# ADDENDUM NO. 1

Perry Township Schools Phase 2:  
Perry Meridian High School Central Plant and Southport High School Electrical Infrastructure  
SPHS: 971 E. Banta Road  
Indianapolis, IN 46227  
PMHS:401 W. Meridian School Rd.  
Indianapolis, IN 46217

**ADDENDUM NO. ONE**

**PROJECT:** Southport High School – Electrical Improvement Package

ED101

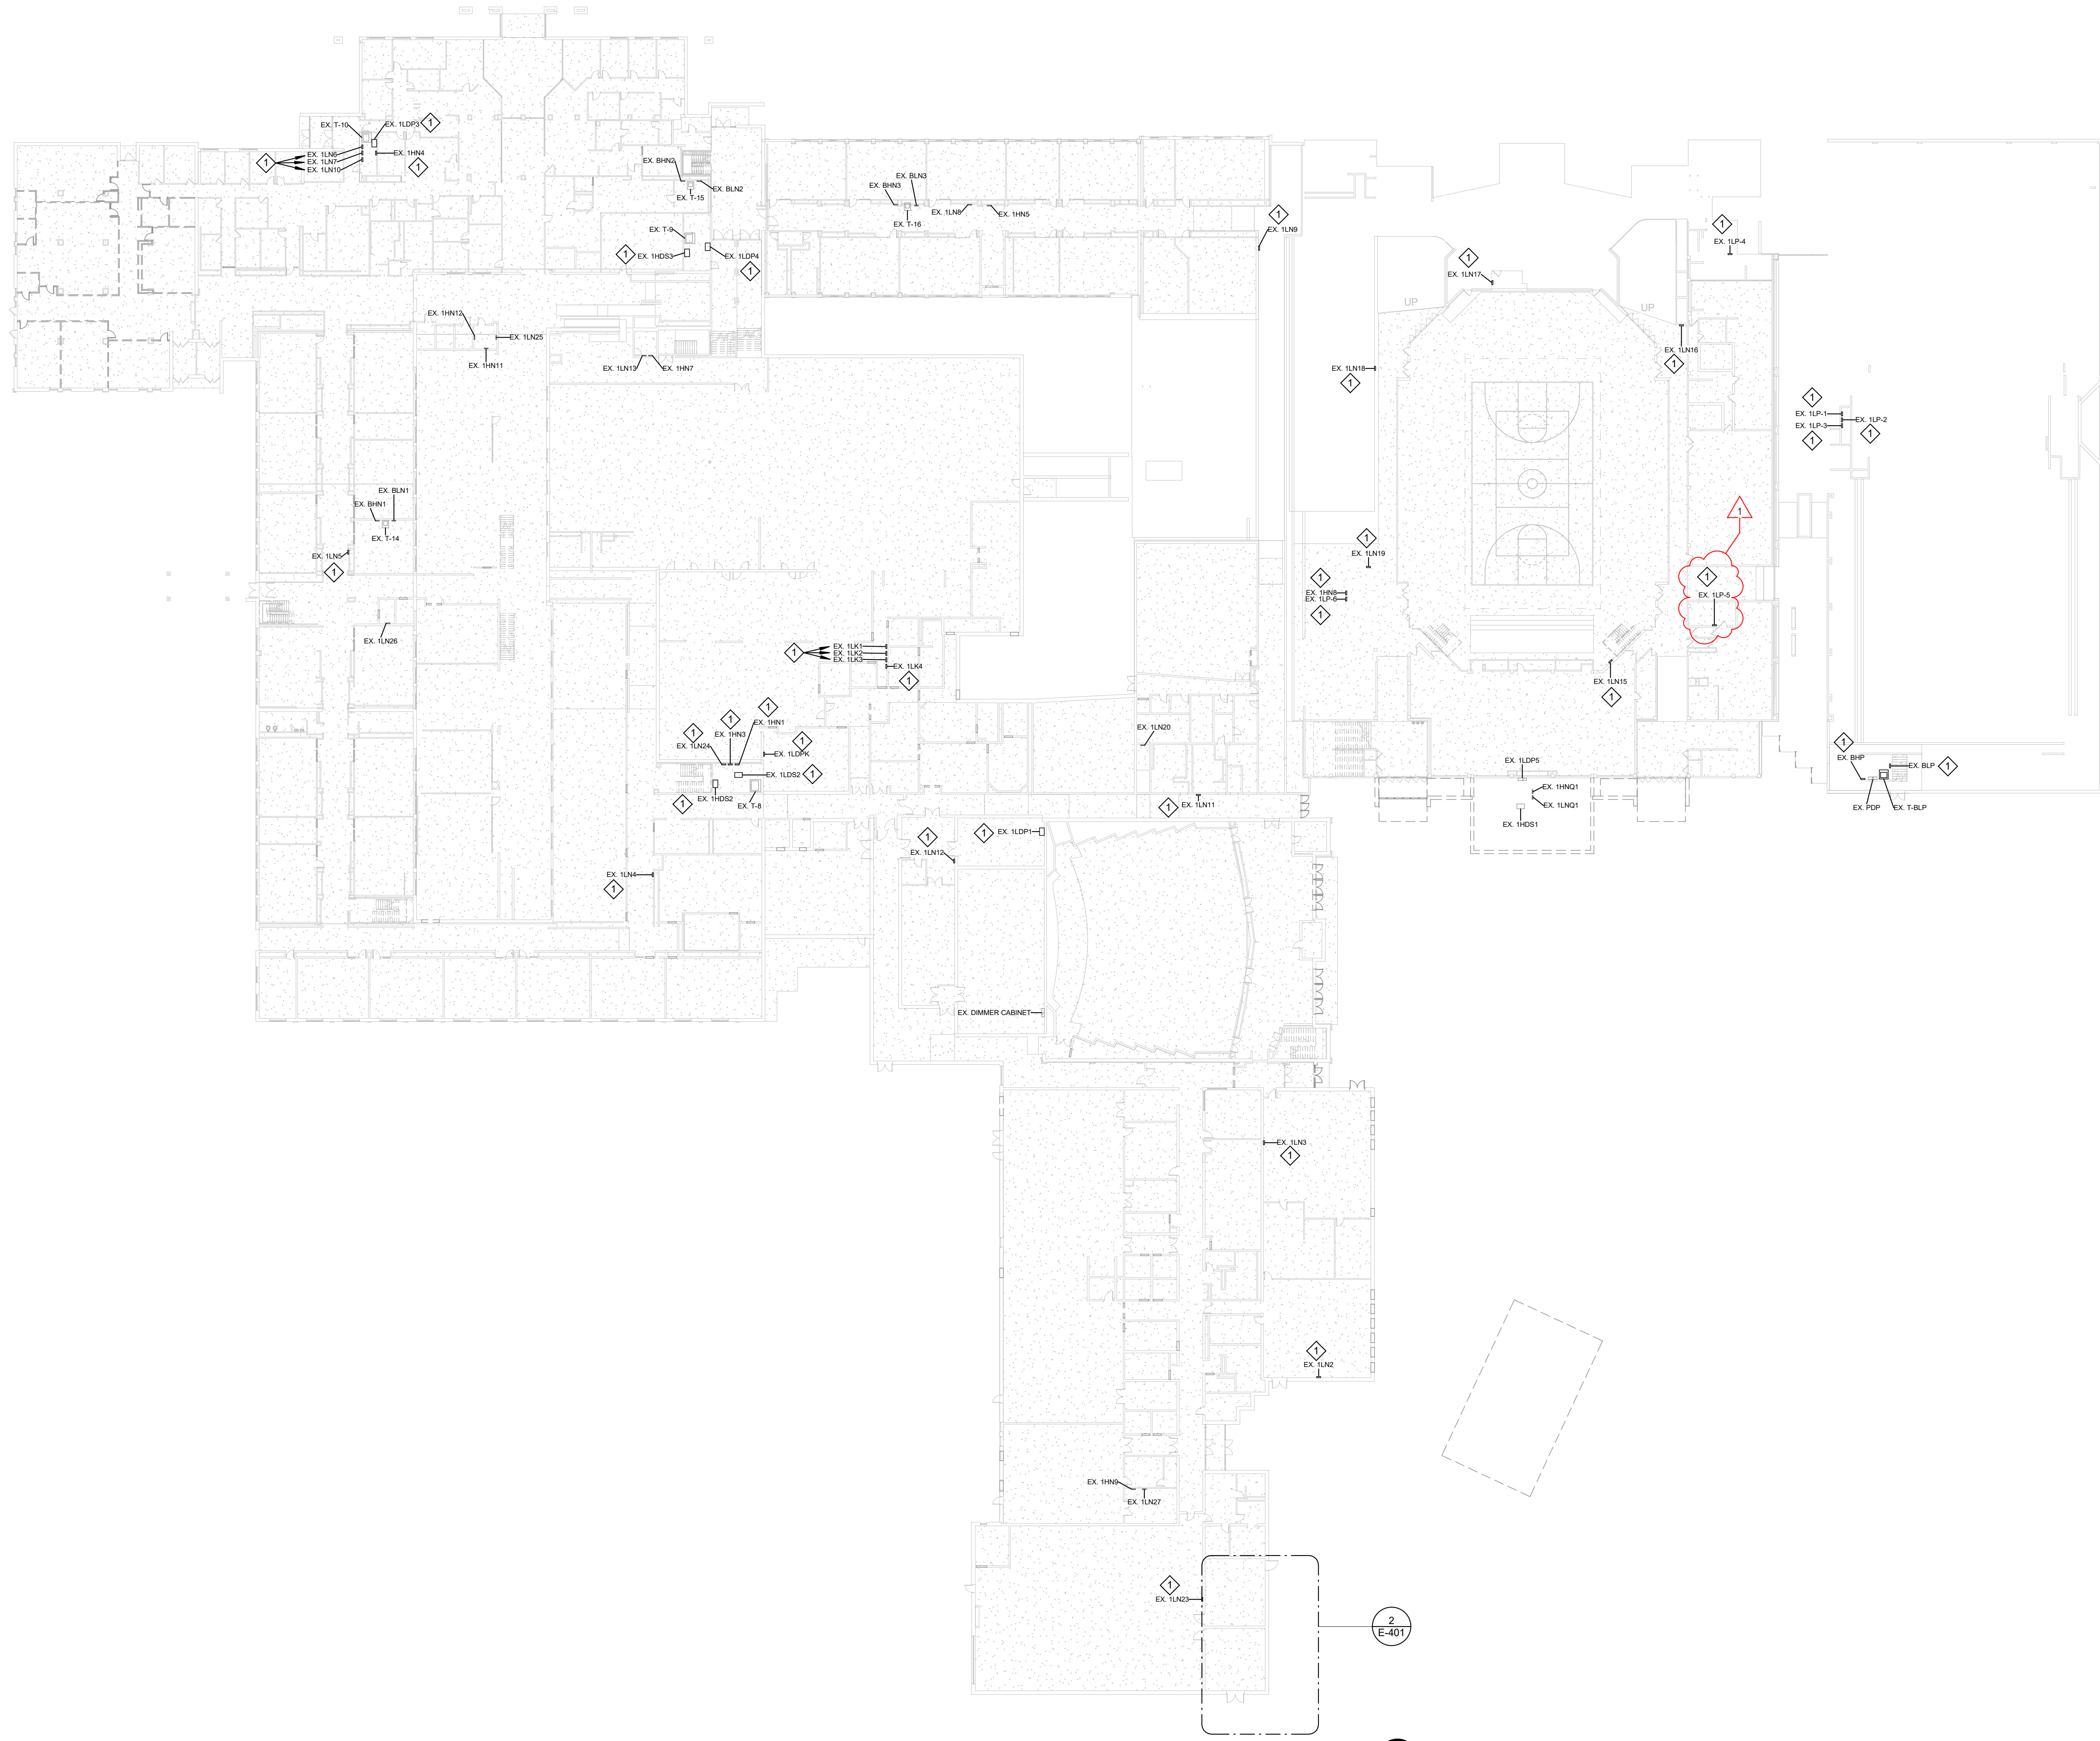
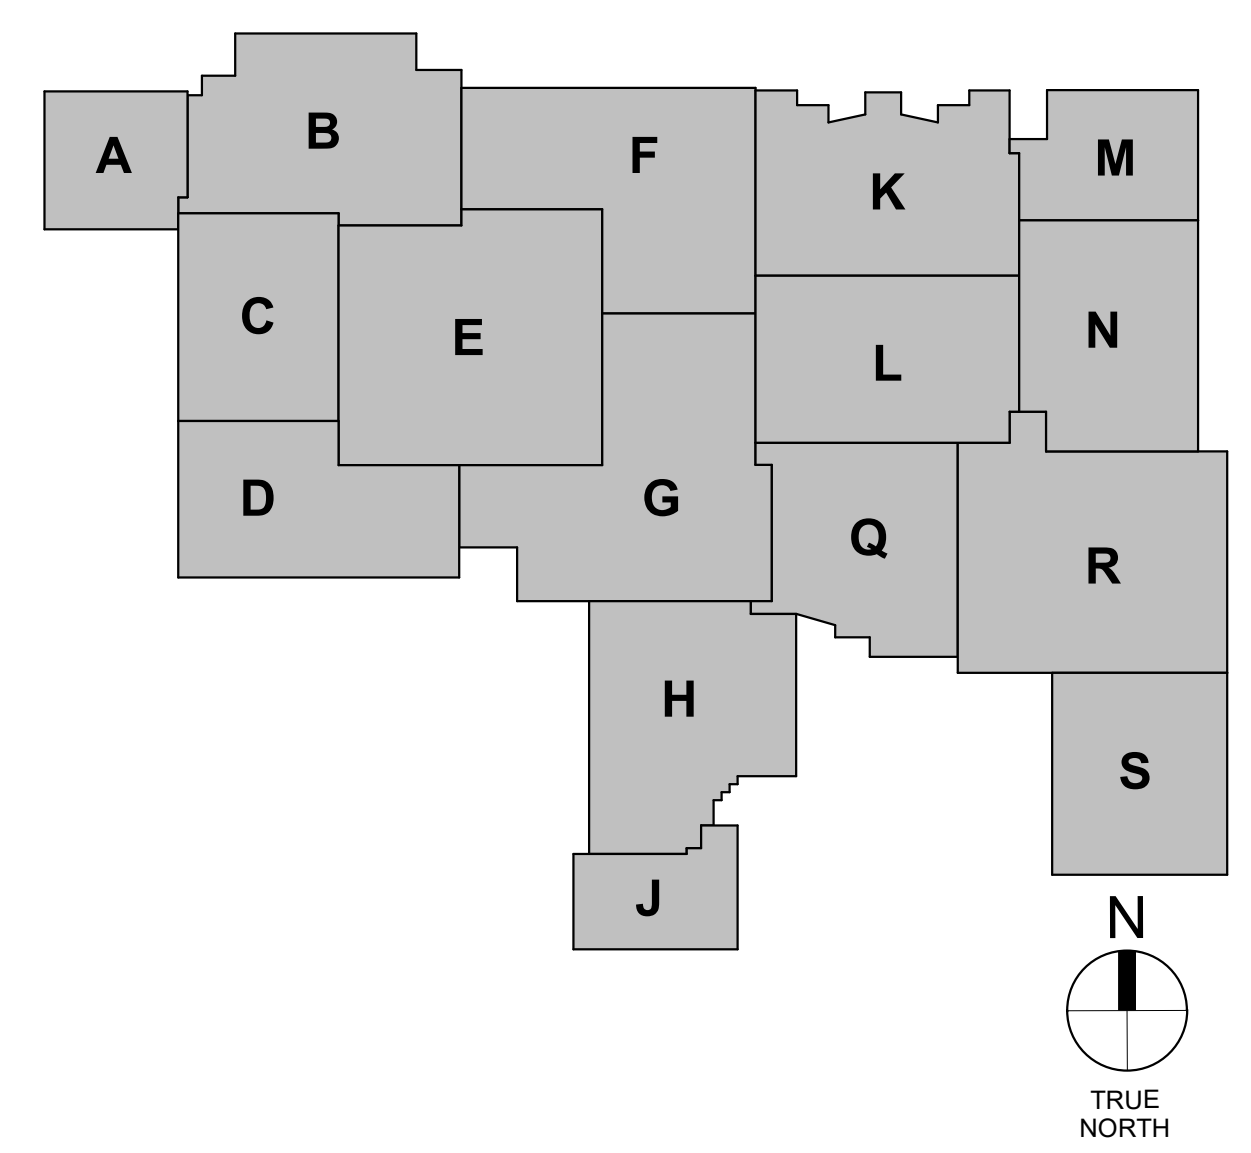
Change: Added panelboard 1LP-5.
2. Drawing Sheet Number: EP101

**EP101**

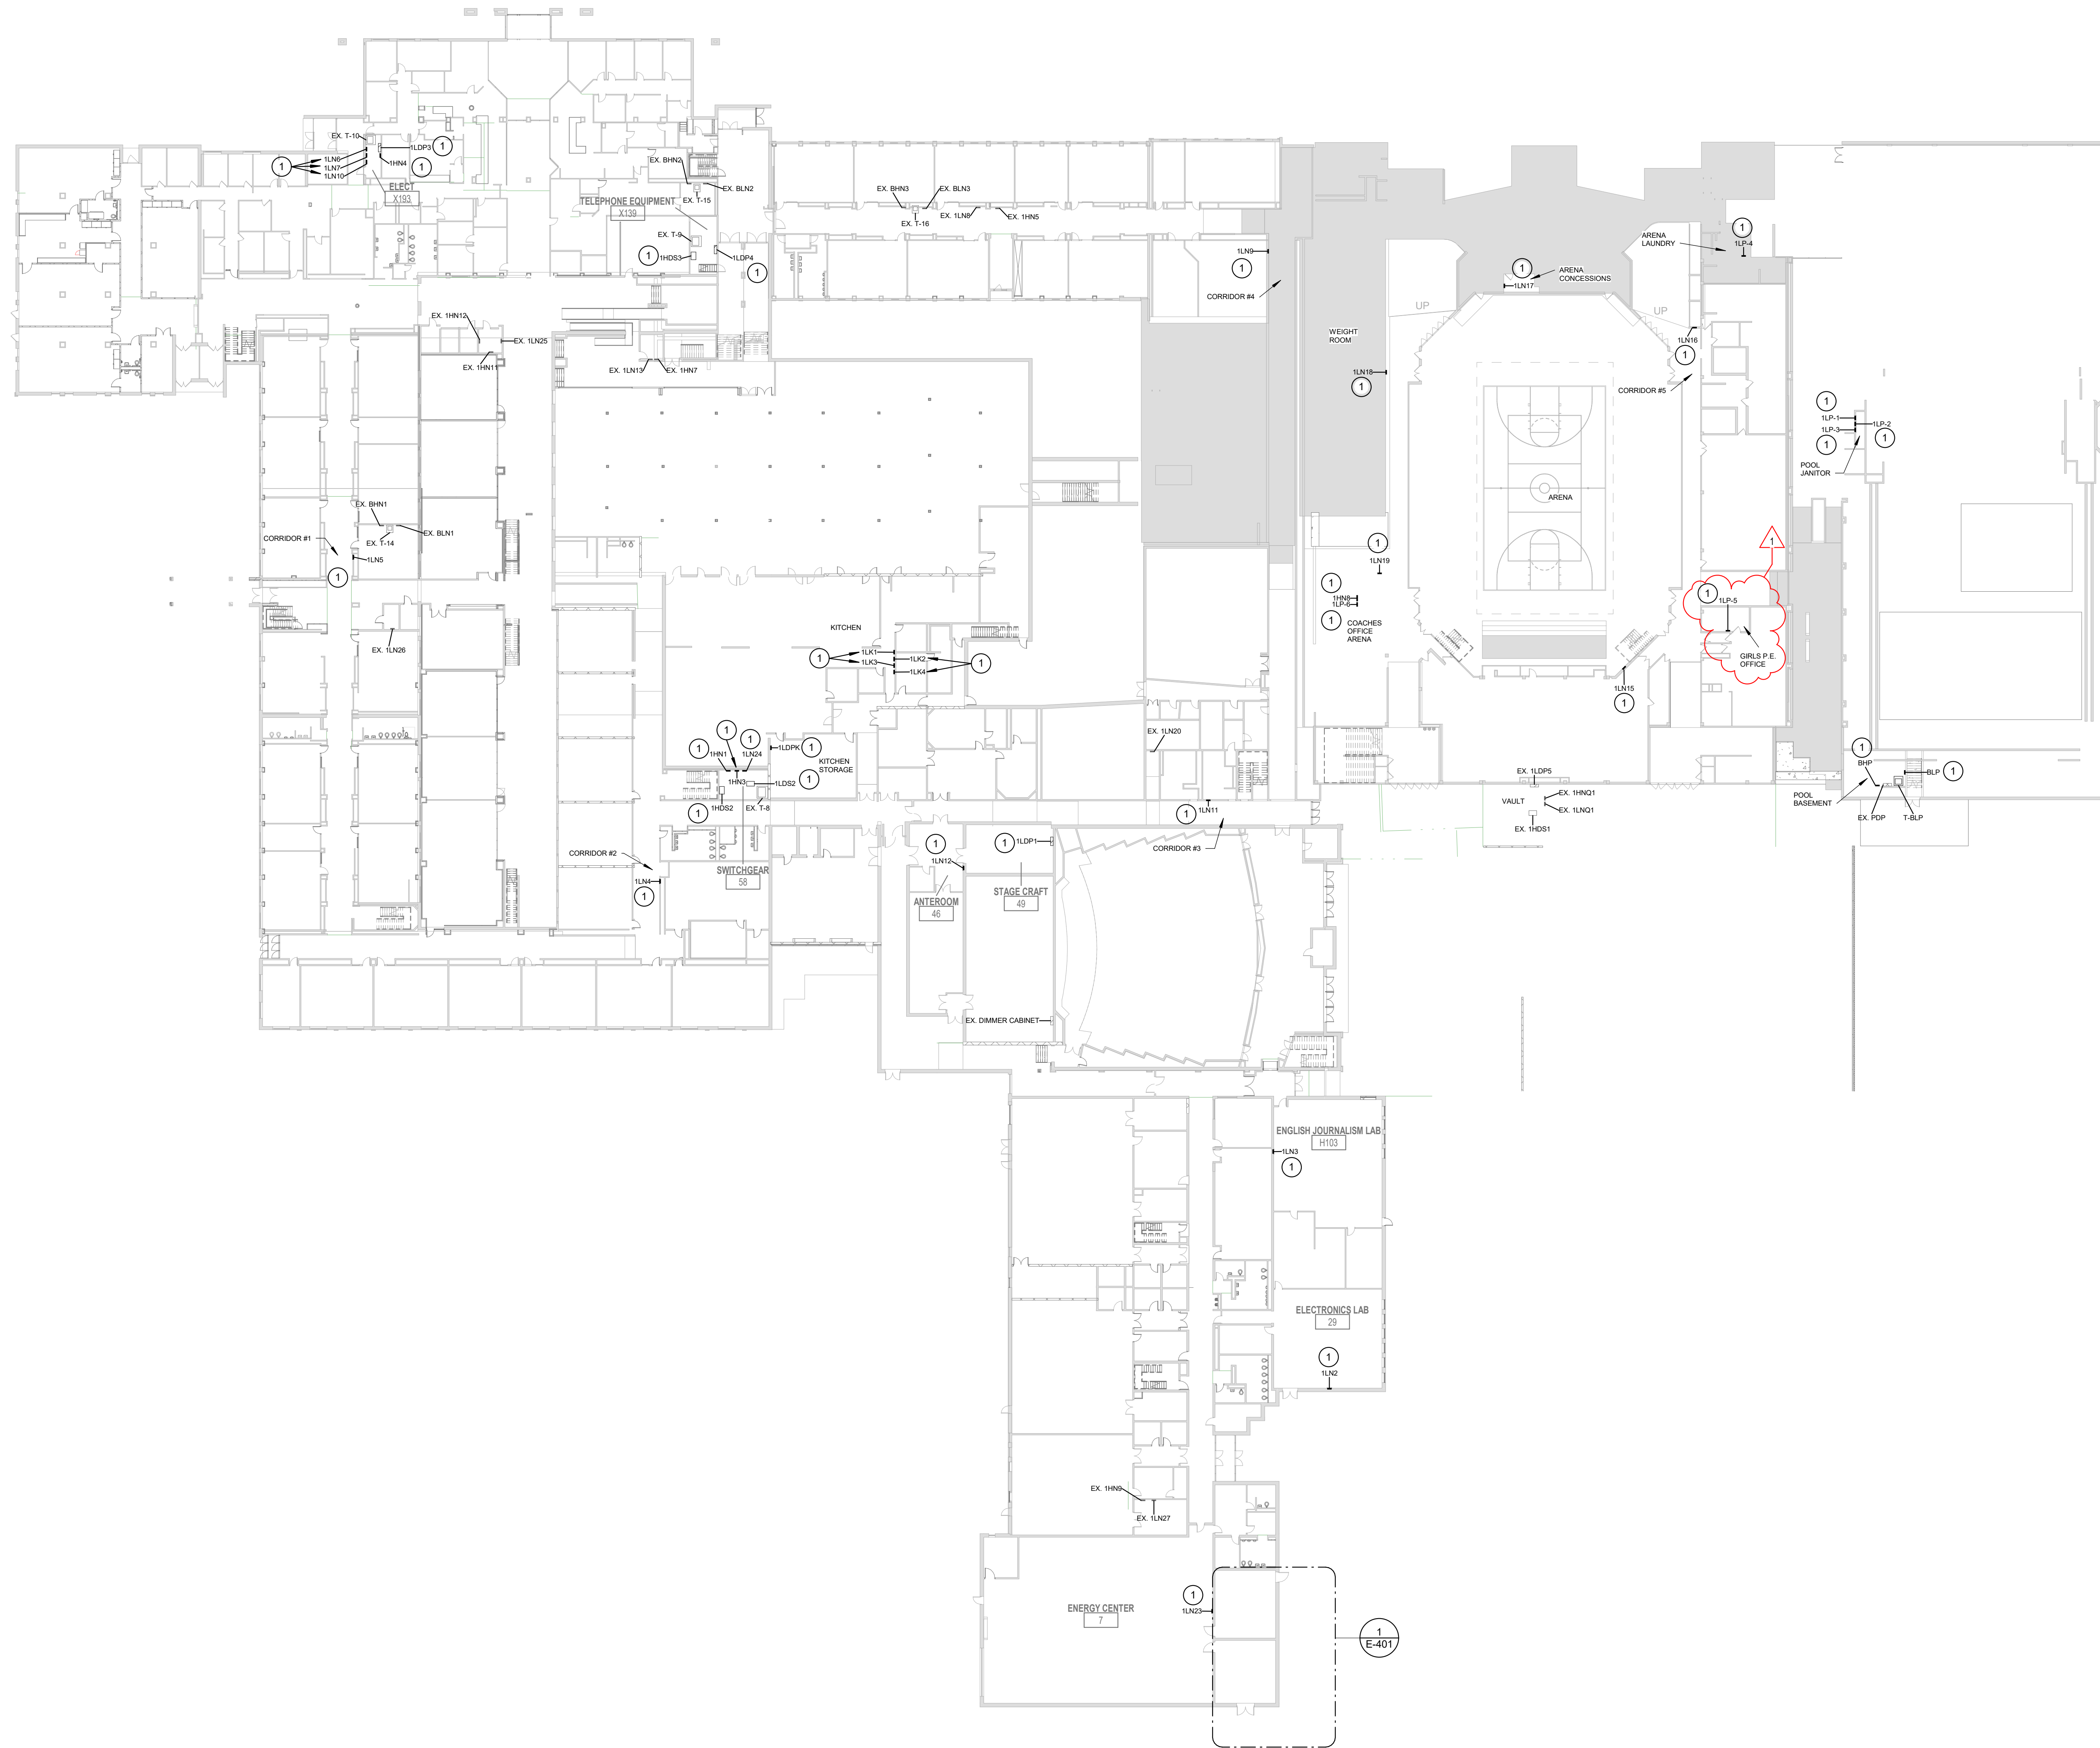
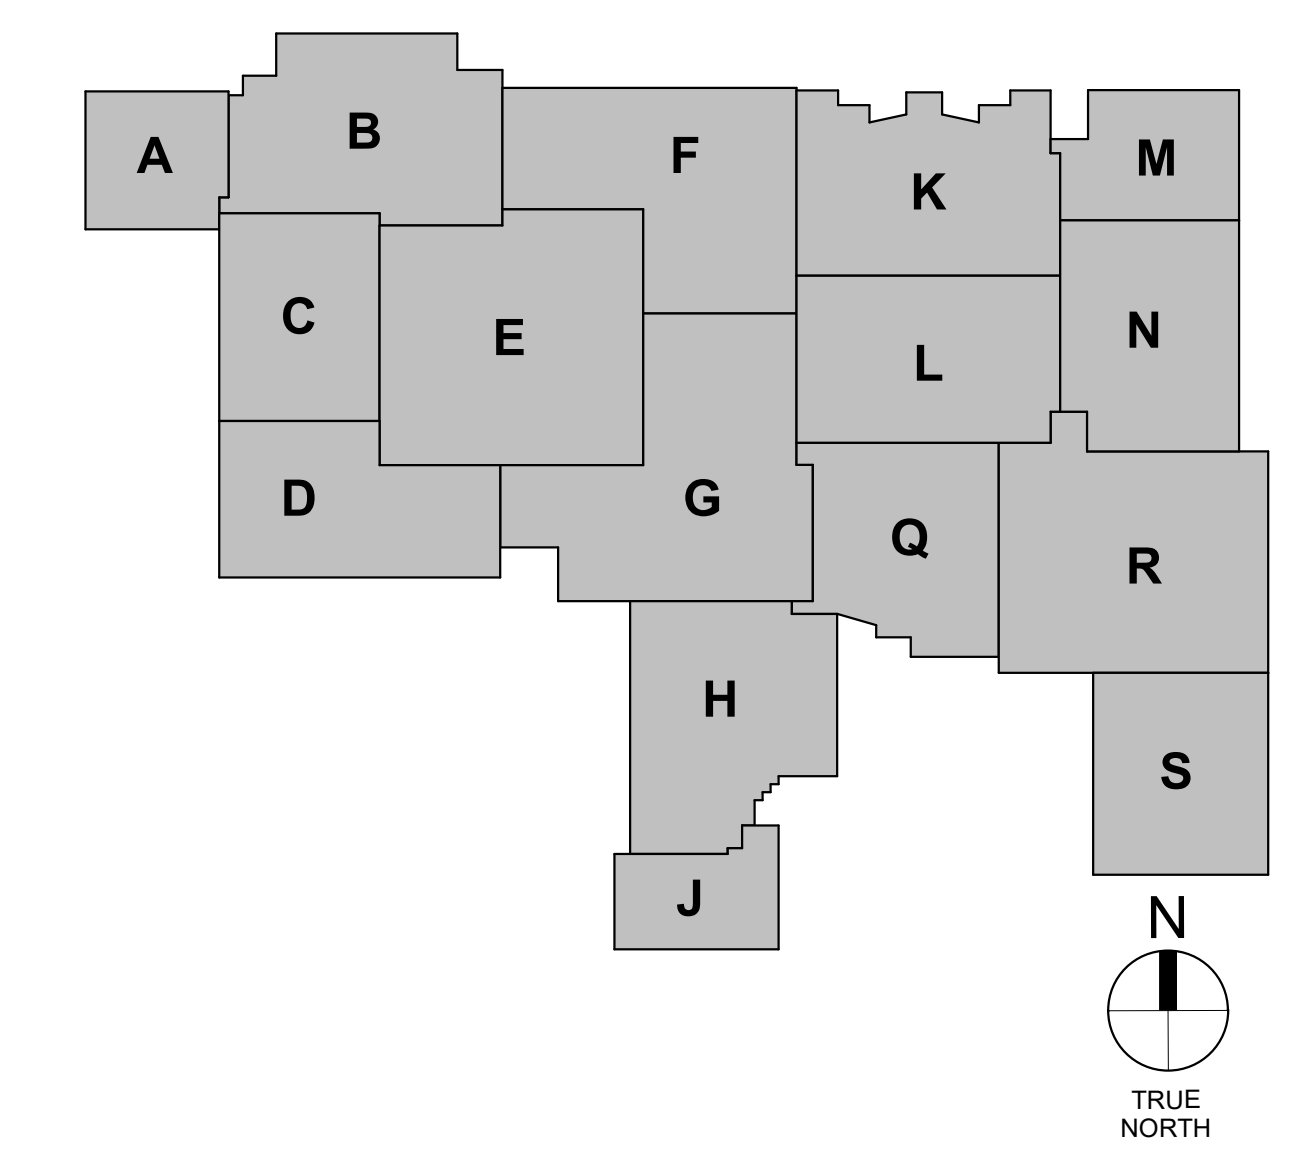
Change: Added panelboard 1LP-5.
